Lemon Creek Ranch Lift Station RFCSP
Solicitation Number: CO-00490
Job No.: 21-3000

ADDENDUM 2
December 6, 2021

DATE: AUGUST 2021	SAWS PROJECT NO. 21-3000	SHEET NO. S2
DESIGN: JEL	KHA PROJECT NO. 068716102	
DRAWN: ELR		
CHECKED: AF

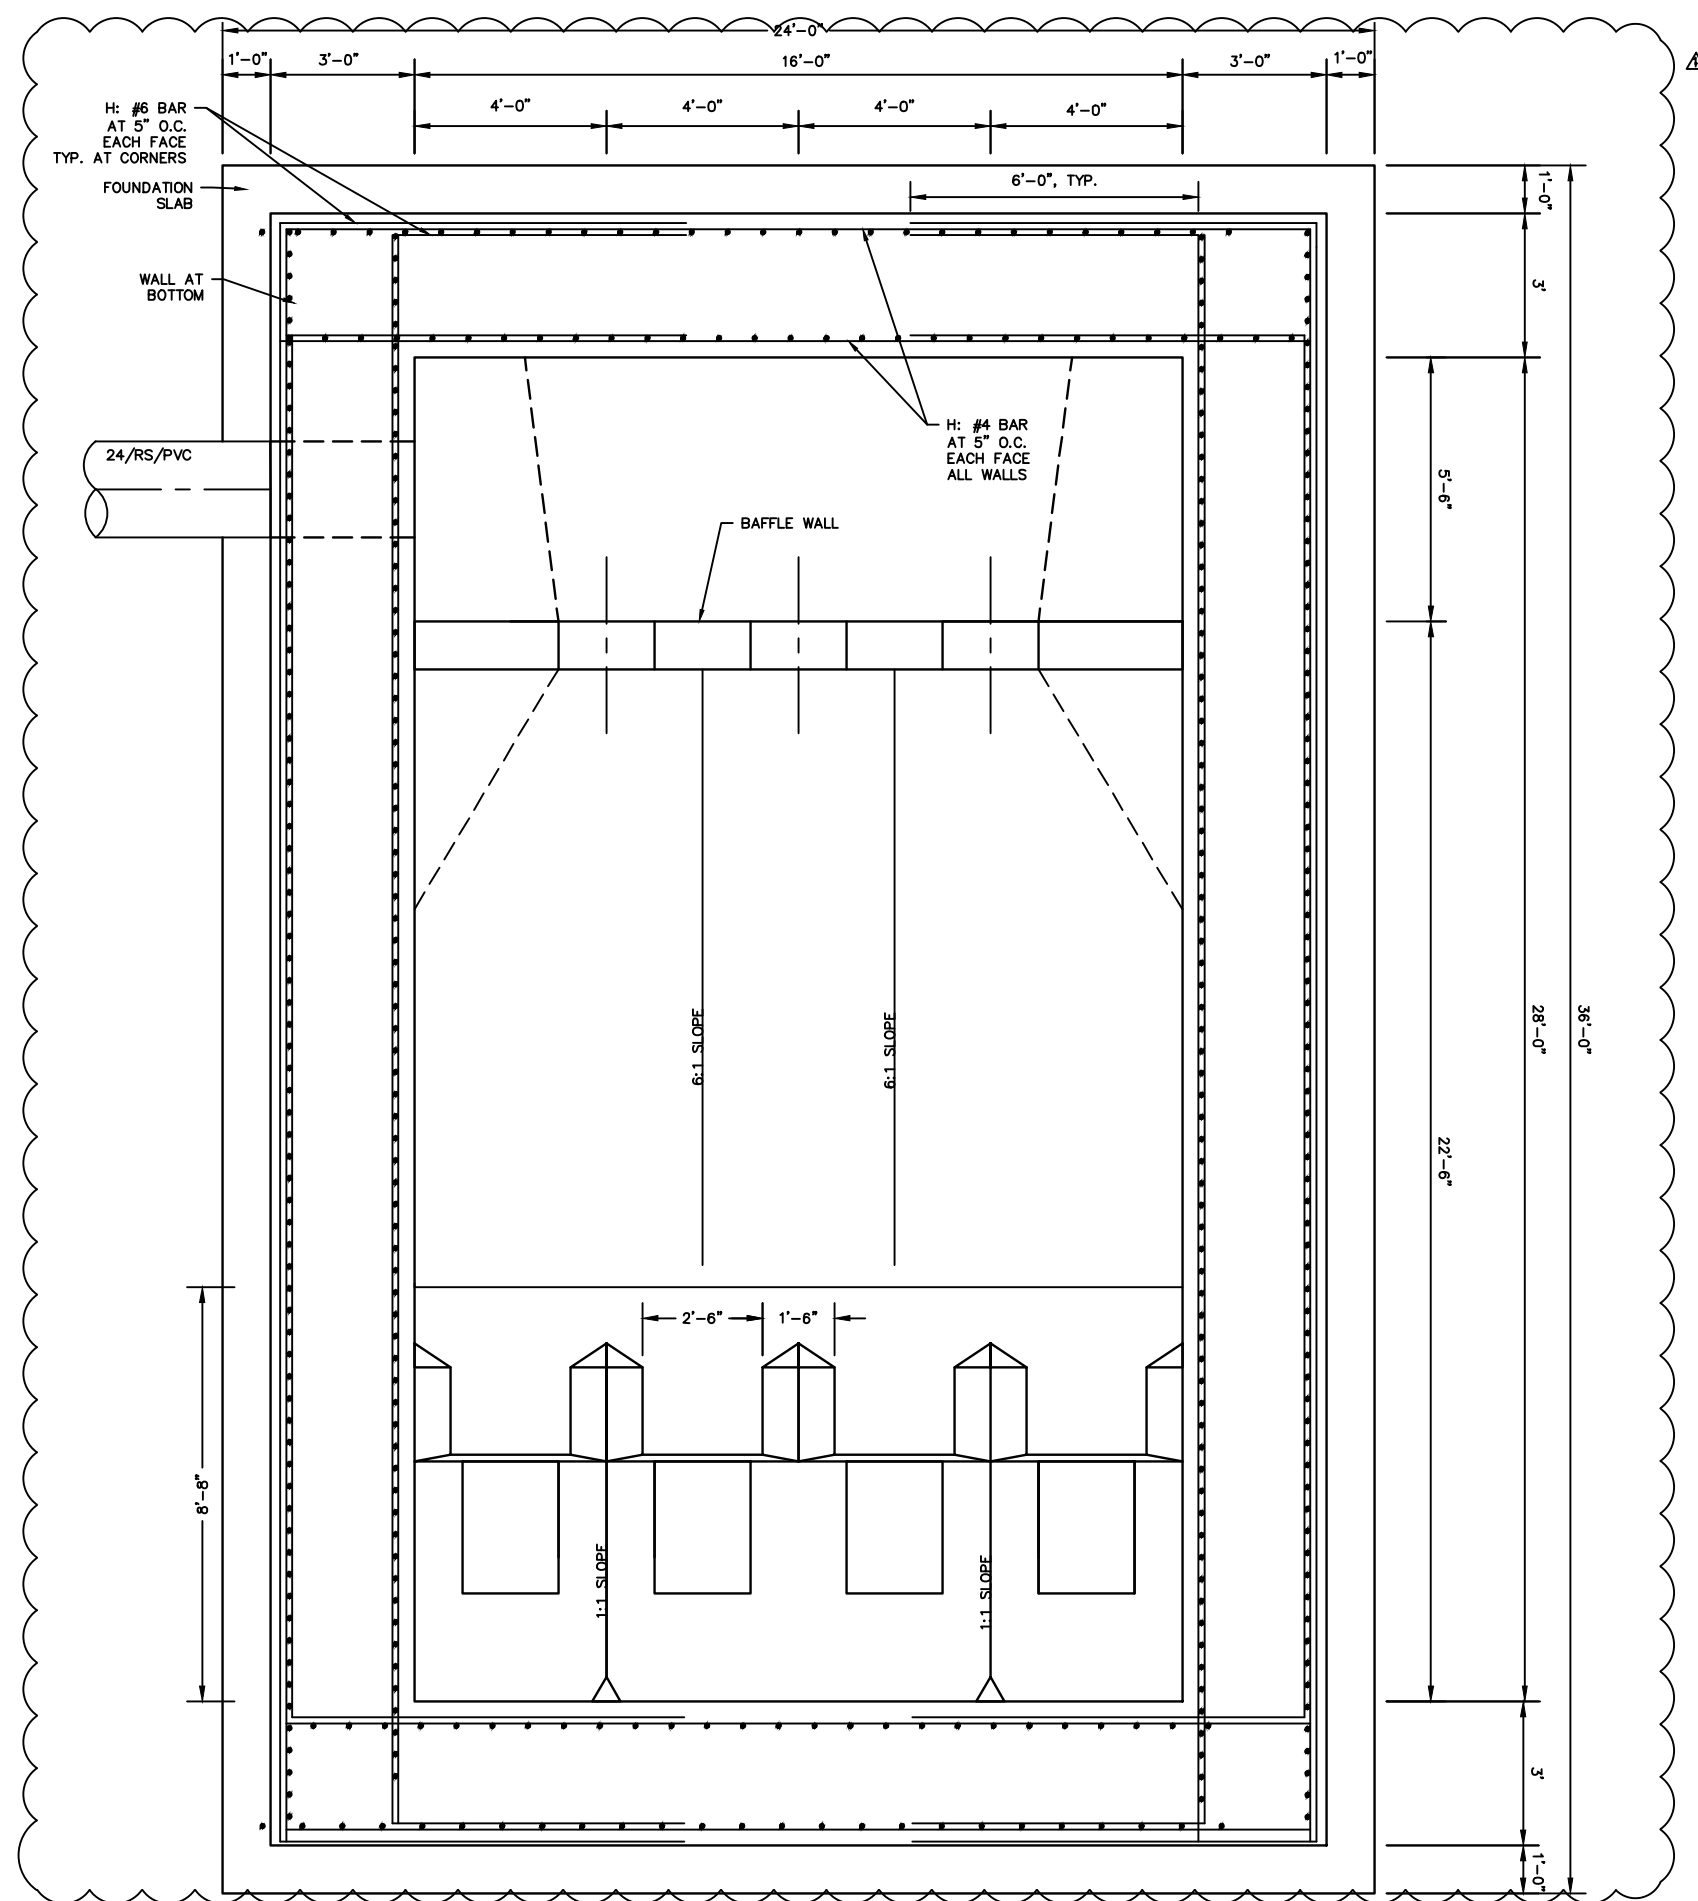
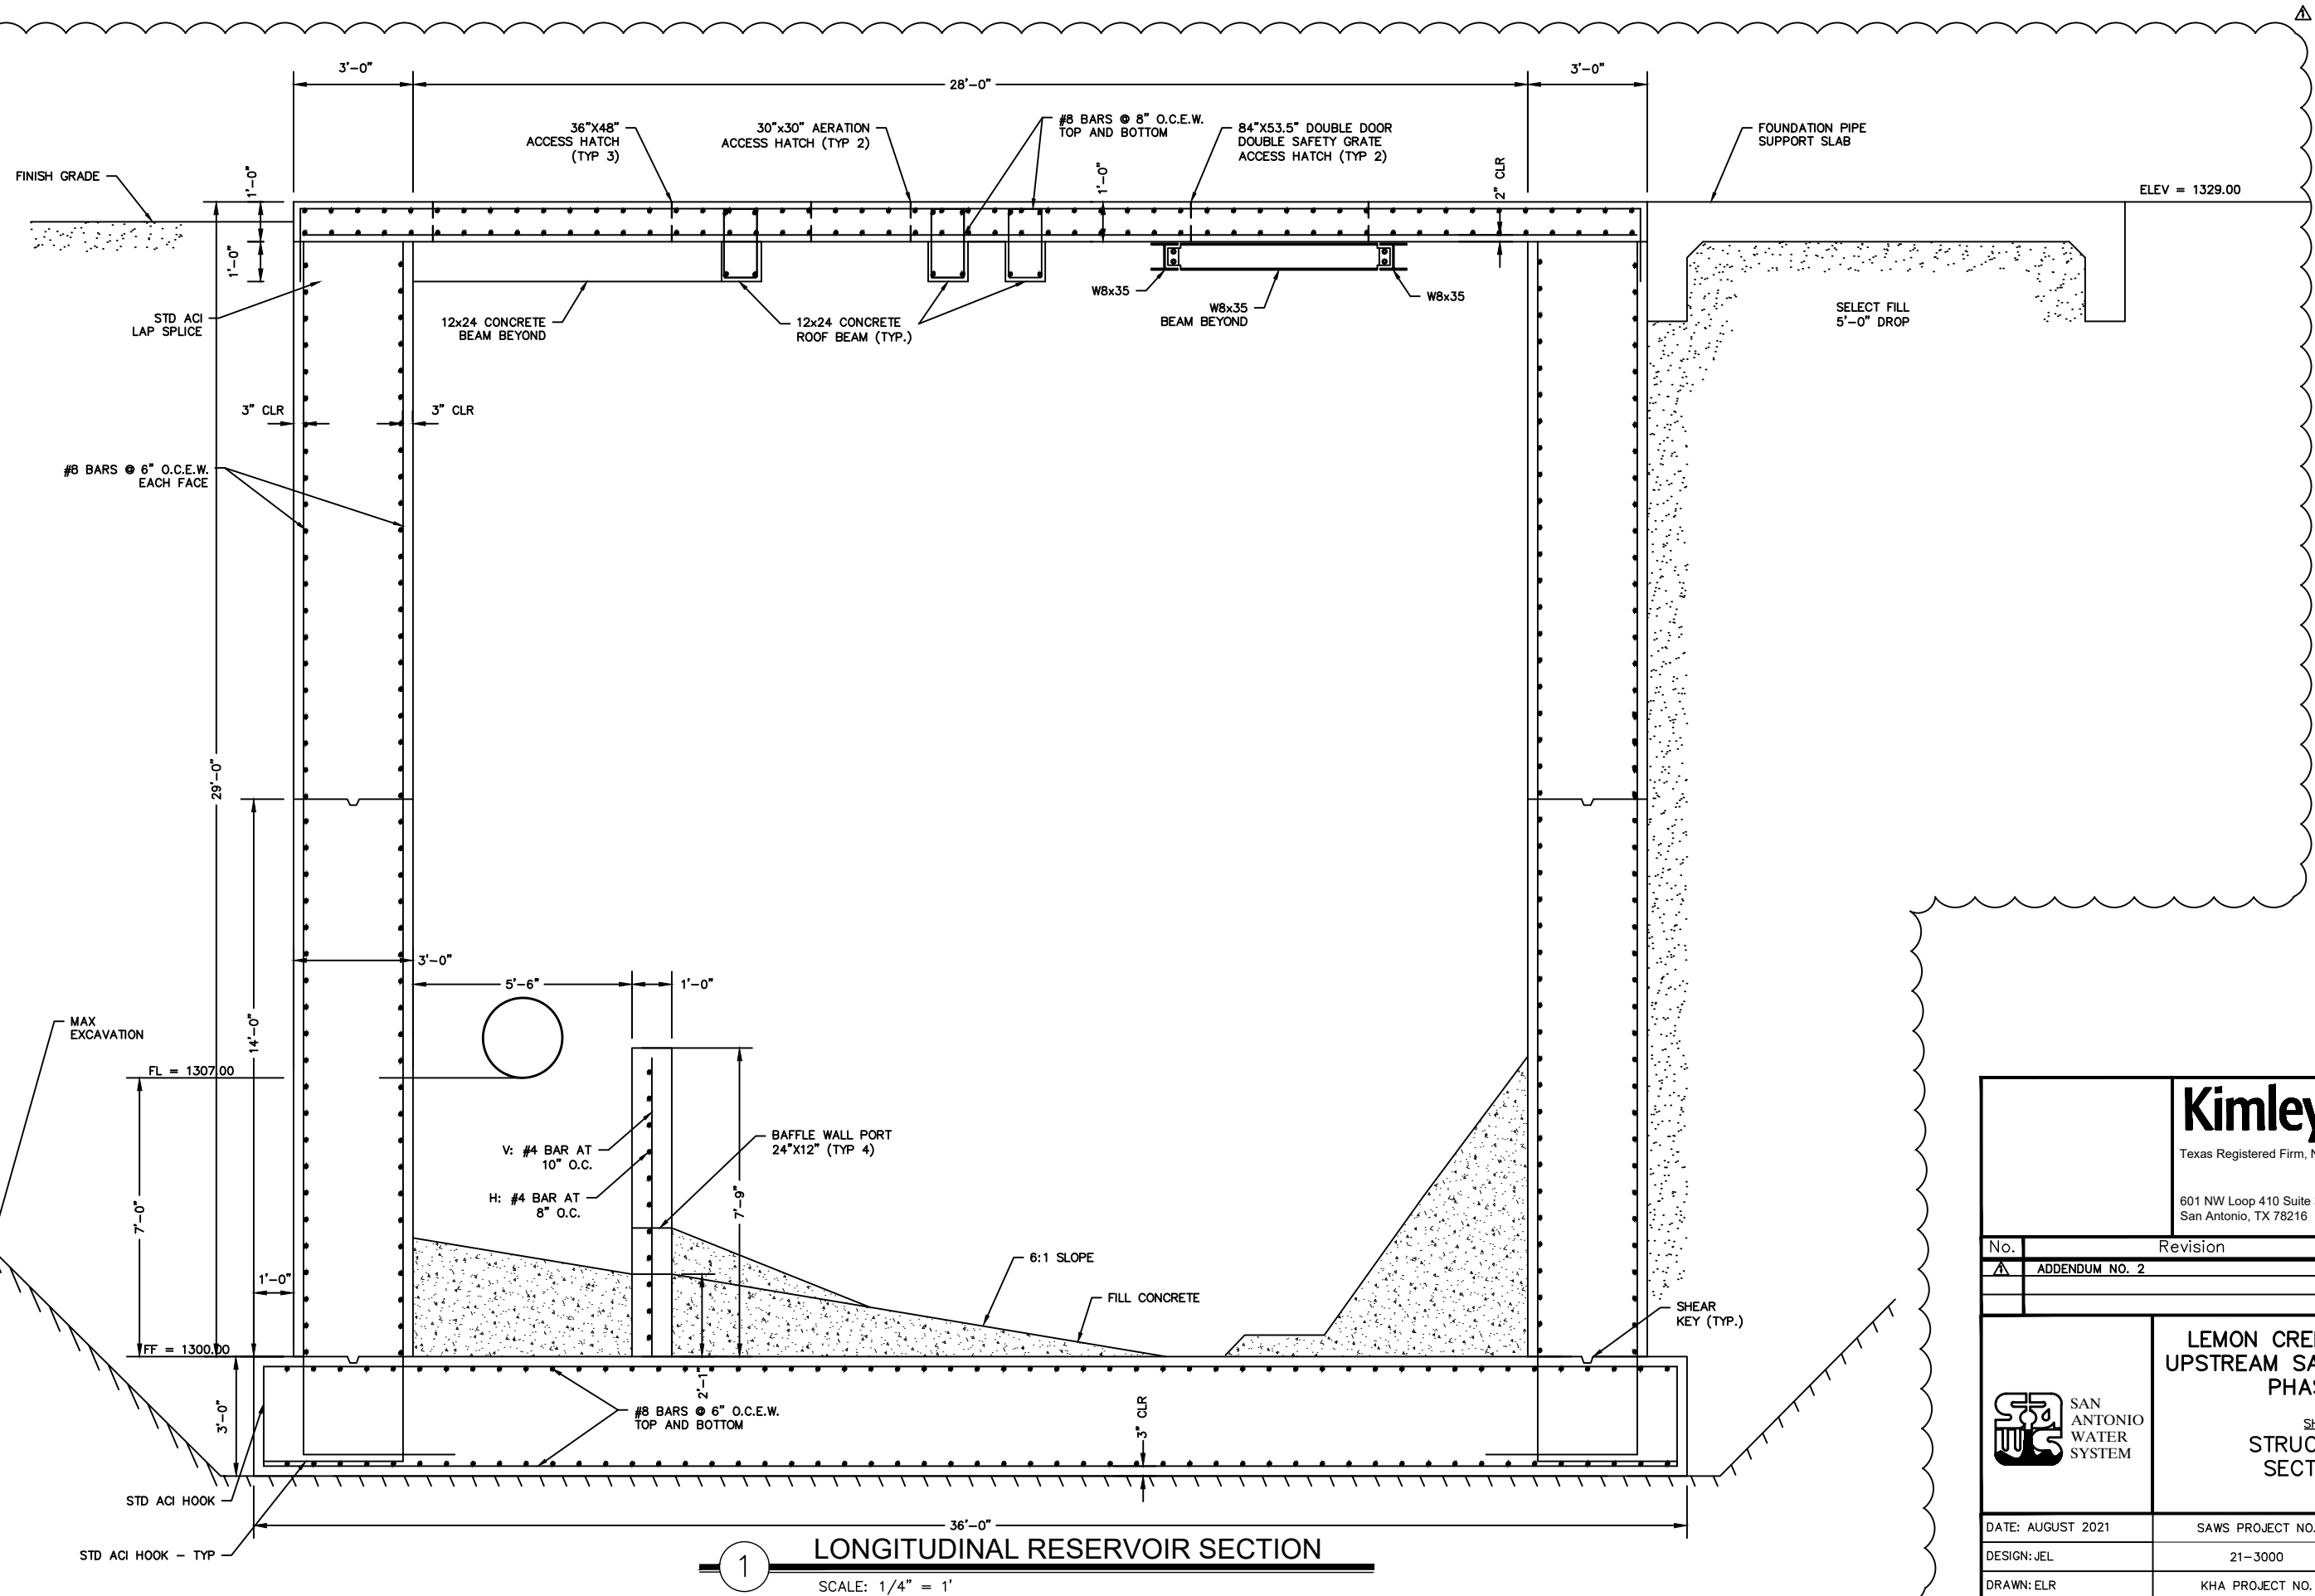
SC 2.0 The Wet Well has been revised to be 29-feet deep from what was previously shown (19-foot deep wet well). There will be a new 36-inch thick concrete wet well and 36-inch wet well foundation (unsealed sheets) re-issued to be part of the base bid. Contractor shall submit a price with the lift station line item 1 that includes the cost of the updated S1/A, S2, S3, S4, S5, S6/A, S7/A sheets.
